Service Bulletin

RUST ON BOTTOM OF REAR DOOR GLASS GUIDE

Bulletin No: 09-014/14

- This bulletin supersedes the previous bulletin 09-026/11 issued on 10/5/11. The **APPLICABLE MODEL(S)/VINS, REPAIR PROCEDURE, PARTS and WARRANTY INFORMATION** have been revised.
- Changes are noted below beside the change bar in Red.

Vehicles Type A

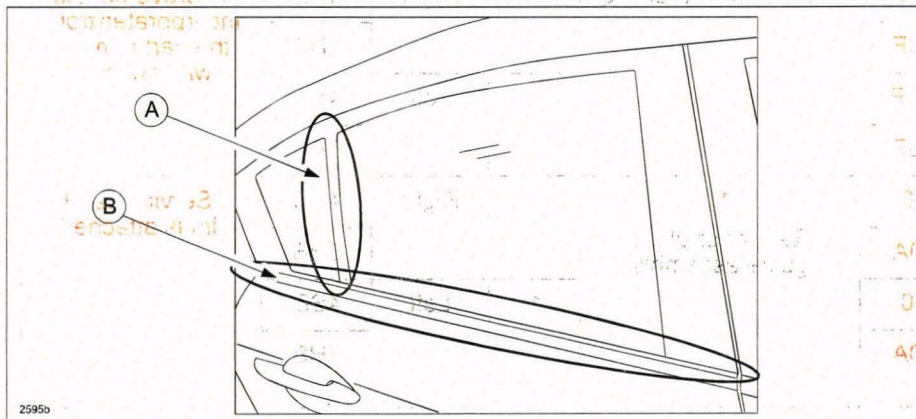
Some vehicles may exhibit rust on the bottom of the rear door glass guide (A) from contact with the rear beltline molding (B). This is caused by a vibration while driving.

At the affected side(s), replace both the the rear door glass guide assembly and the rear beltline molding with modified ones. Refer to MS3 online instructions or Workshop Manual section 09-12 REAR DOOR QUARTER GLASS REMOVAL/INSTALLATION and 09-16 REAR BELTLINE MOLDING REMOVAL/INSTALLATION.

A: Rear door glass guide

B: Rear beltline molding

Vehicles Type B

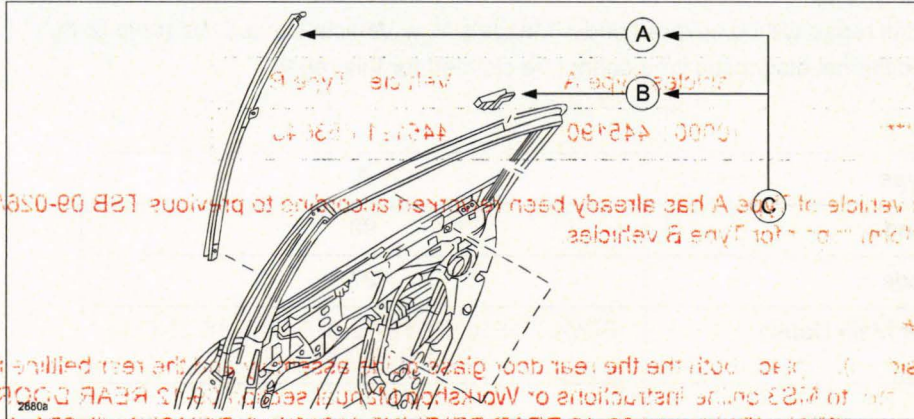
At the affected side(s), replace the rear door glass guide assembly (C) with a modified one. Refer to MS3 online instructions or Workshop Manual section 09-12 REAR DOOR QUARTER GLASS REMOVAL/INSTALLATION.

A: Rear door glass guide (film is attached)

B: Protector (current part)

C: Rear door glass guide assembly (service part)
